**CITY OF SAMMAMISH  
SAMMAMISH ADDENDUM TO THE  
2021 KING COUNTY SURFACE WATER DESIGN MANUAL  
Effective Date: 6/29/2022**

**PREFACE – How to Use this Document**

**Section 4.1.2 EASEMENT AND SETBACK REQUIREMENTS** (page 4-3 of the KCSWDM) – Add the following figure as a supplement:

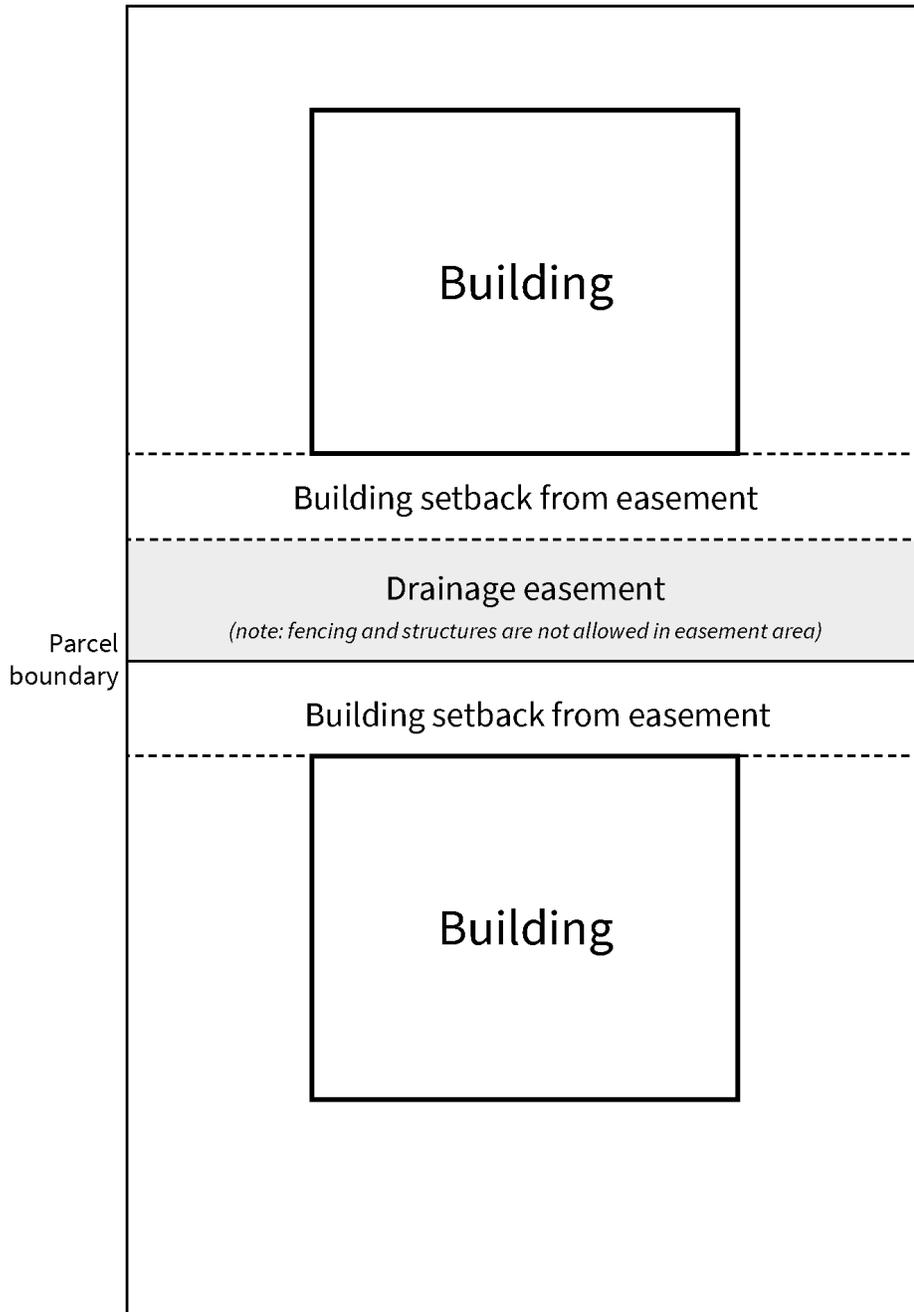
See Section 4.1.2 of the King County Surface Water Design Manual for easement and setback details.

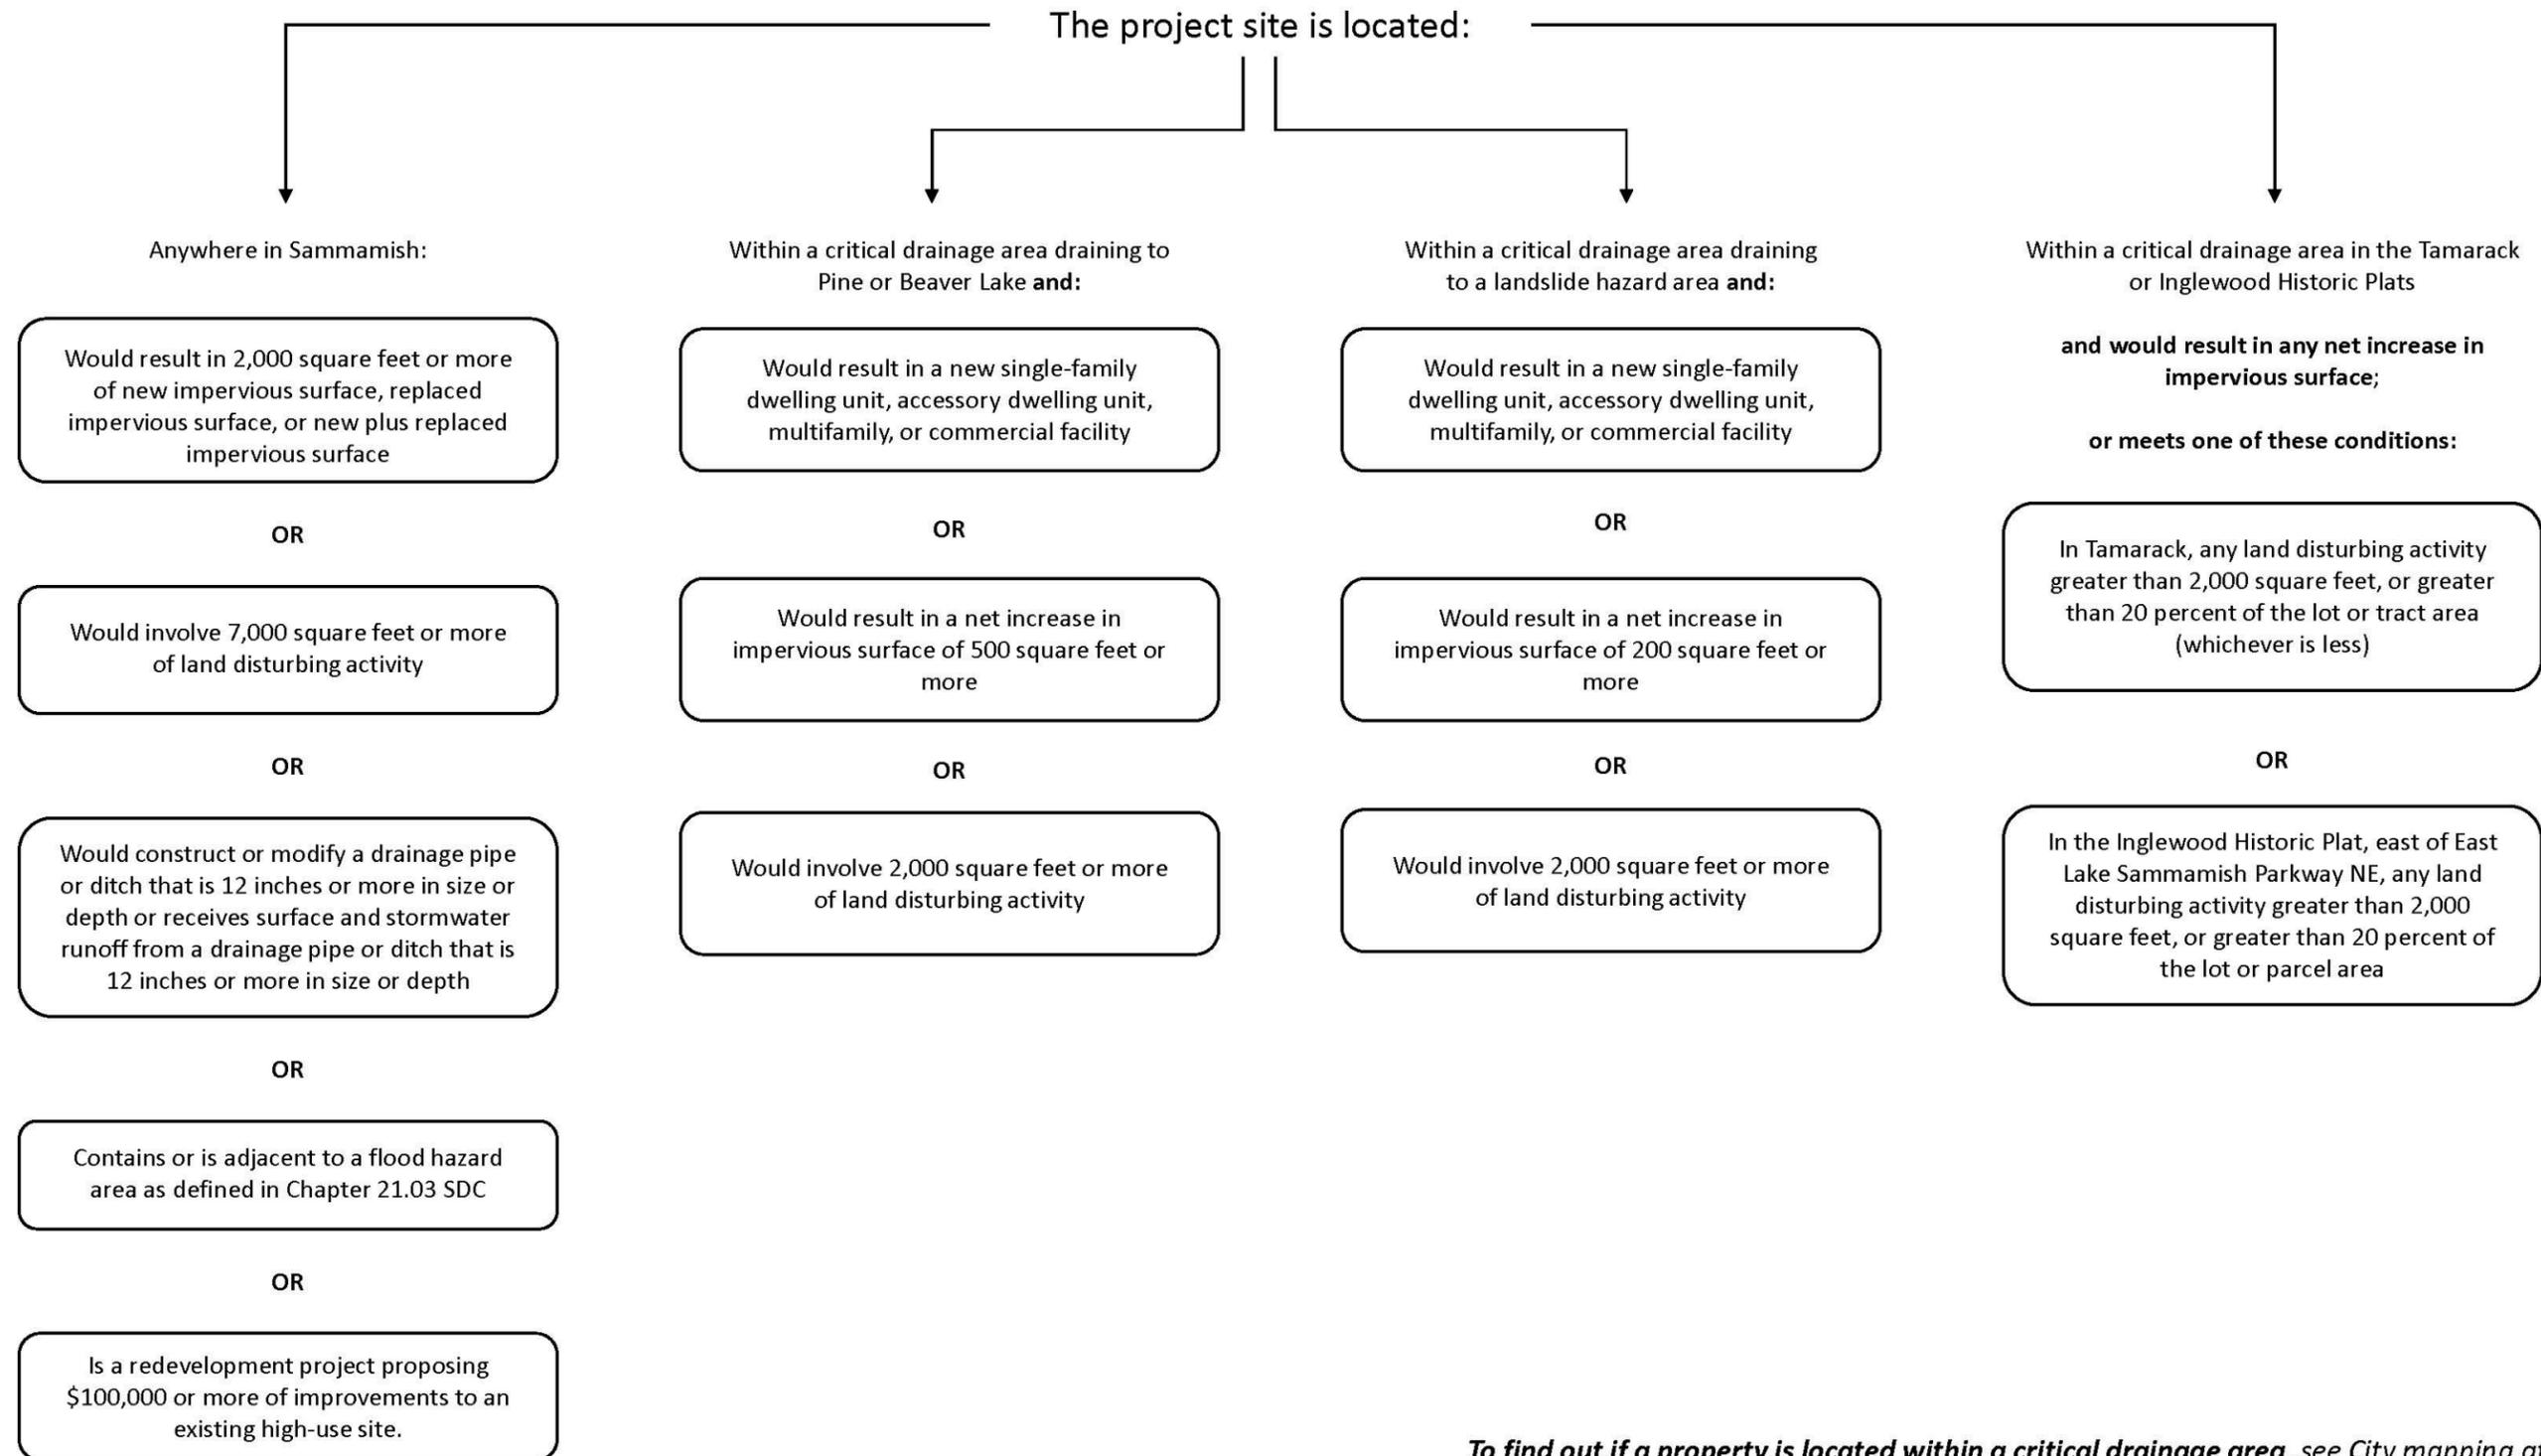
- **Section 5.1.1.1 DESIGN CRITERIA, Figure 5.1.1.D Stormwater Facility Signs (page 5-16 of the 2021 KCSWDM)** — Replace Figure 5.1.1.D with the figure in Attachment B of this addendum.
